DRAINAGE INFORMATION SHEET

PROJECT TITLE: _____ ZONE ATLAS/DRNG. FILE #: J13/D42

LEGAL DESCRIPTION: E 1/2 BLOCK 20 PEREA ADD.

SUBJECT: ALLEY AT LOMAS AND FRUIT: CITY WORK ORDER PROJECT #3472

8' ALLEY DATA

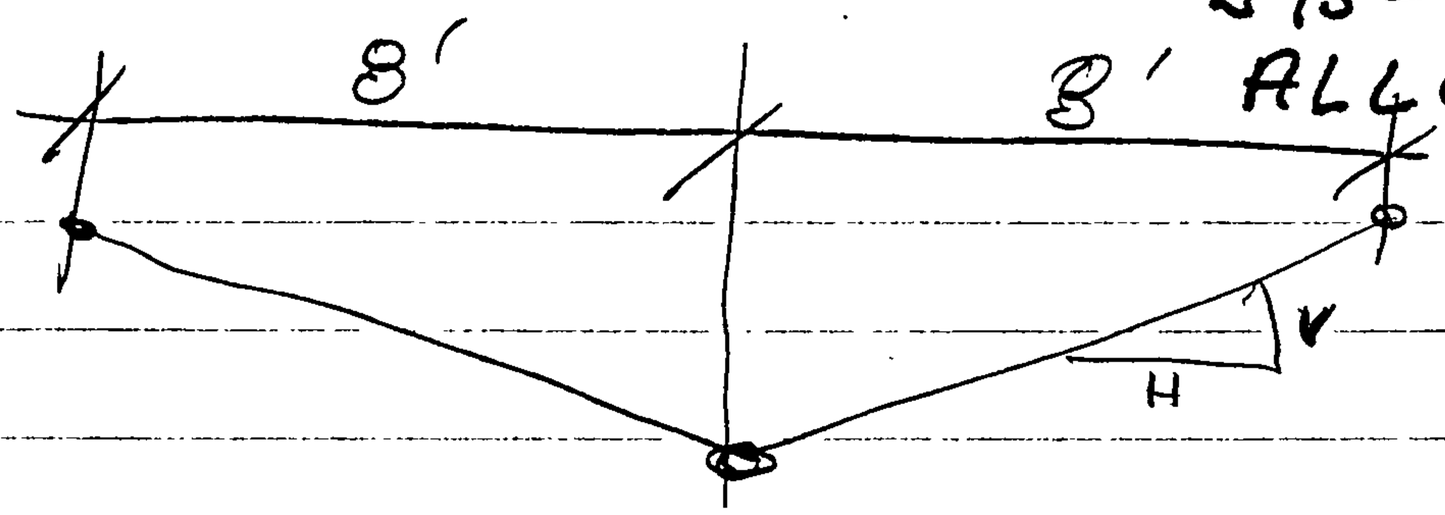
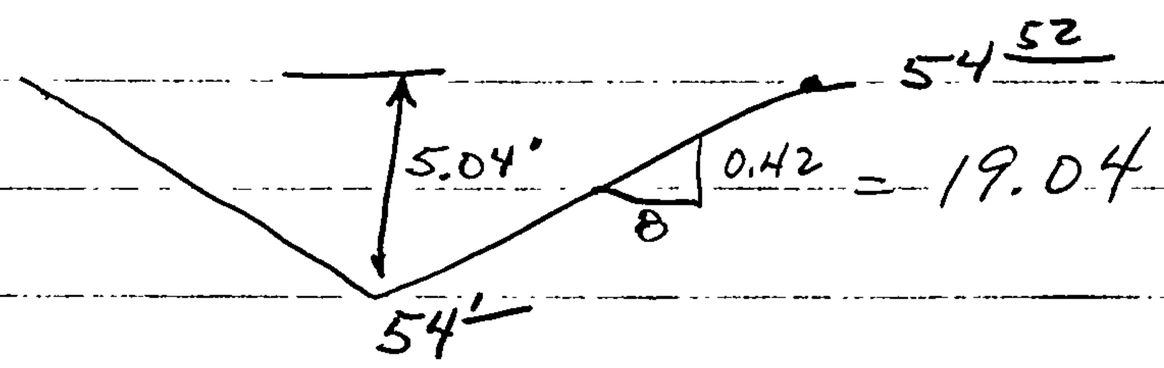
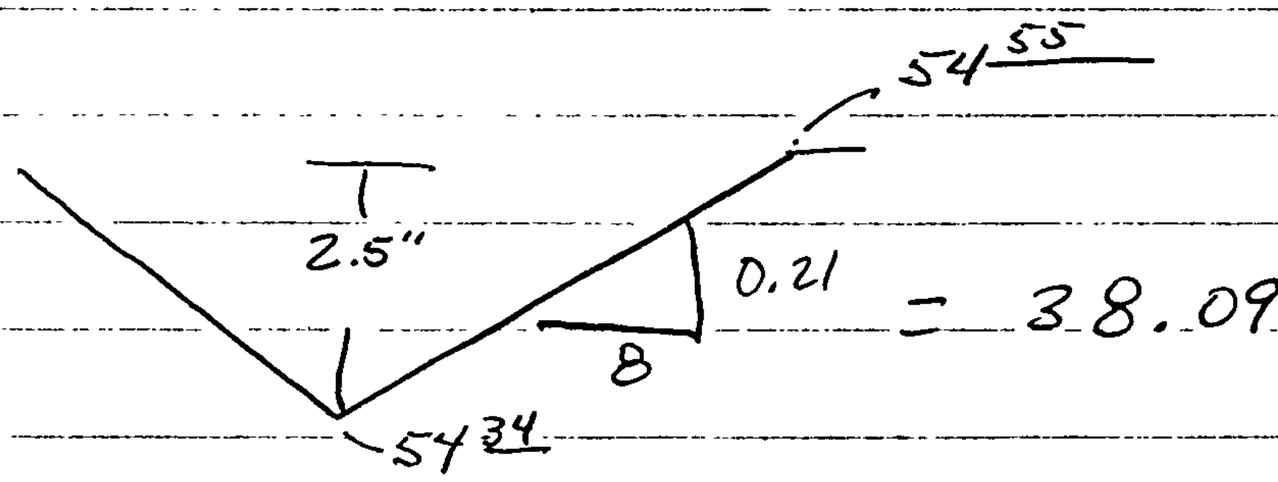
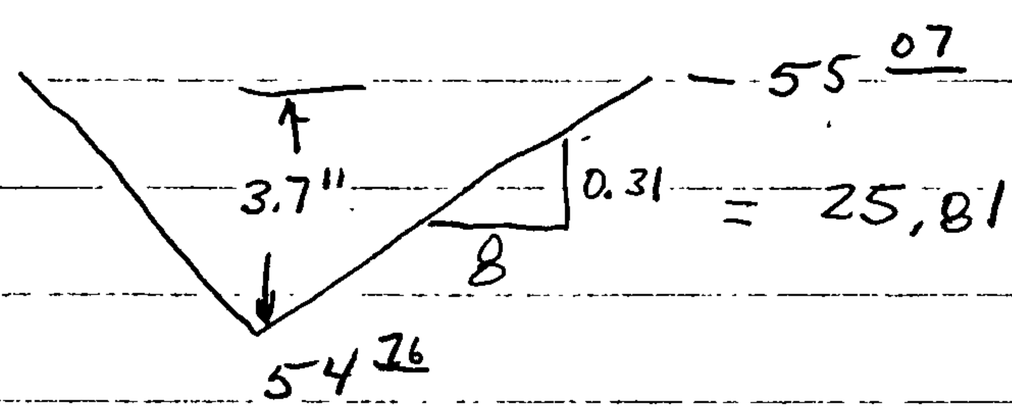
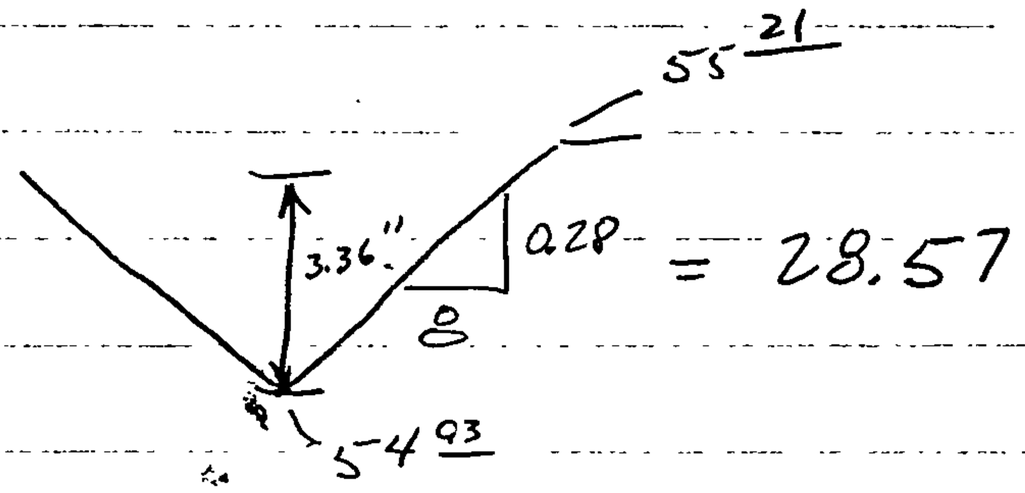
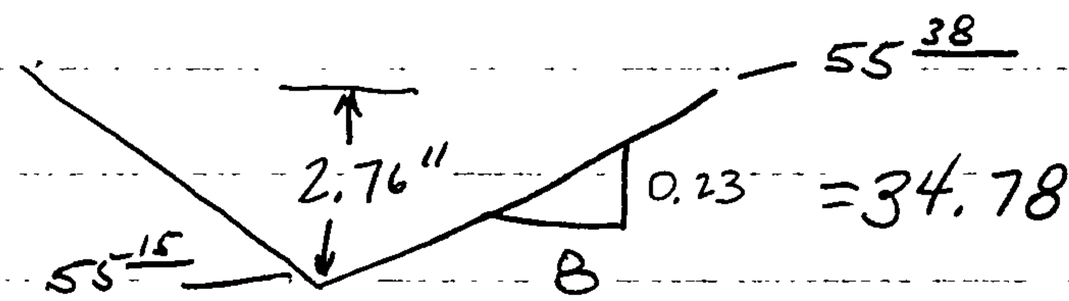
Released C.O. for Perea Addition. Used the survey submitted by Richard Norton on the alley to determine capacity. Attached is the survey by Richard Norton (2-16-89); Alley data; and output data for the alley.

Re: Alley in Block 20 of the Perea Addition

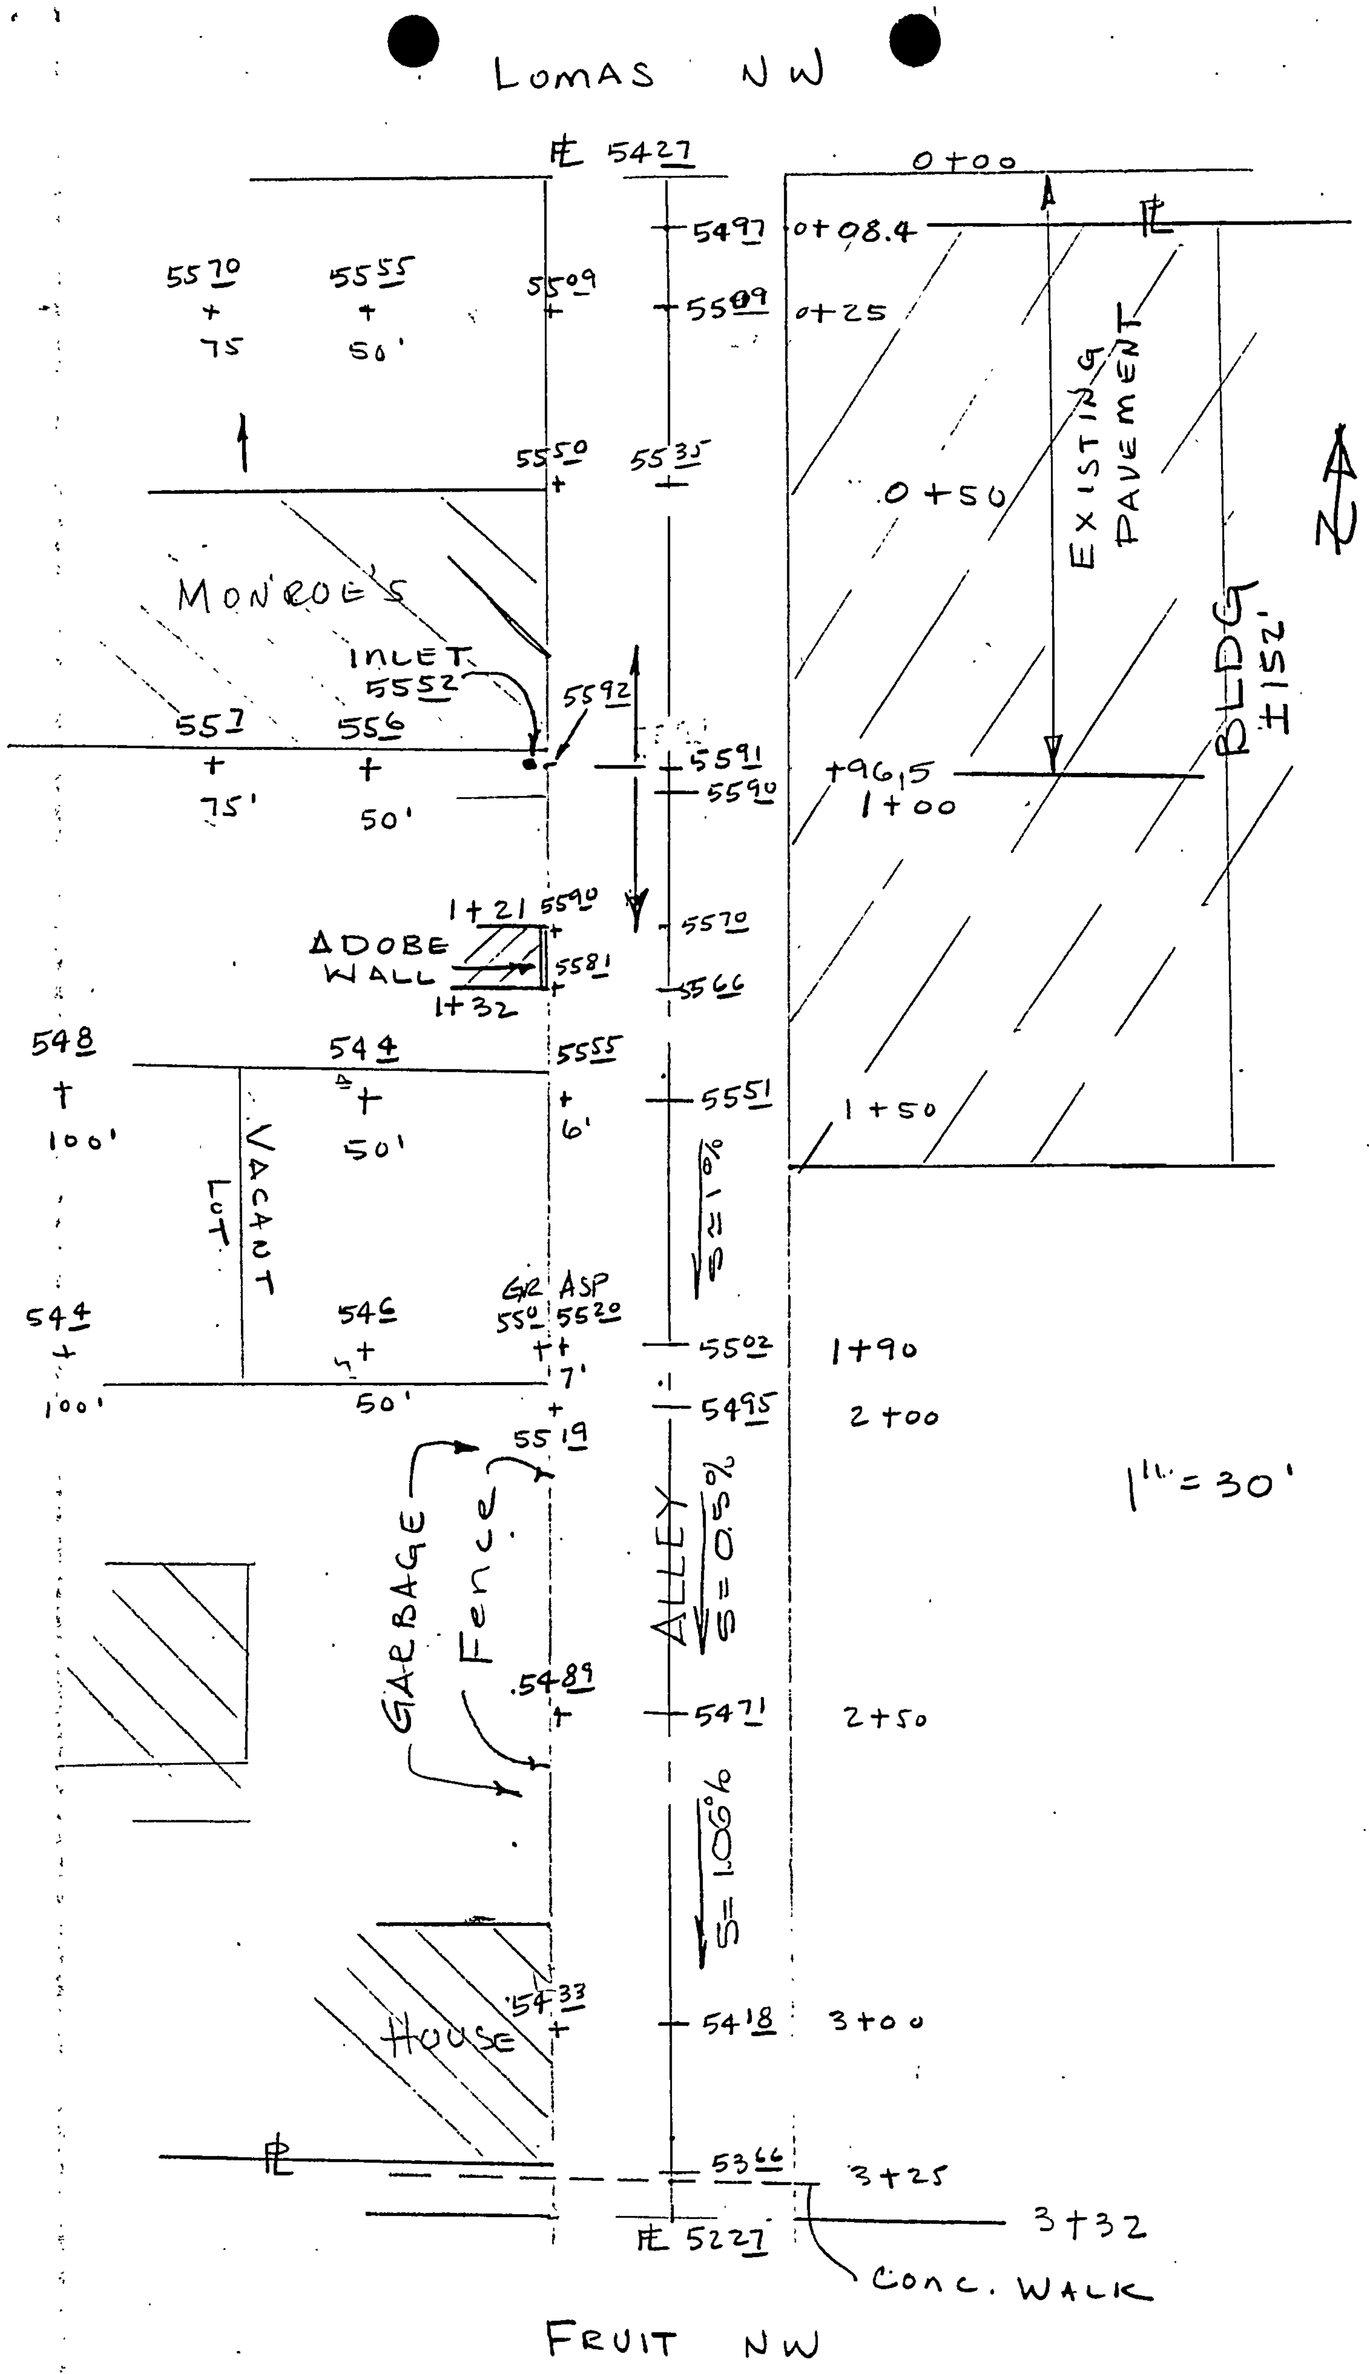
This is in response to your concerns regarding the contractor's variance from the design of the alley. I have rechecked the "as built" elevations and enclose sketch plan that shows both the alley and the property to the west.

It is my opinion that the alley as constructed achieves a satisfactory solution to the drainage conditions in the area:

1. The "as built" slope to the south has been increased to facilitate the runoff down the alley.
2. The inverted crown is sufficient to prevent drainage from spilling on to the property to the west.
3. The drainage from centerline to the property to the west does not change.
4. By raising the grade, the contractor has avoided disturbing the foundations of the various buildings and walls along the west property line.

The latter point is important. Excavation along the west line of the alley would seriously endanger the integrity of the existing structions with little or no offsetting benefit.
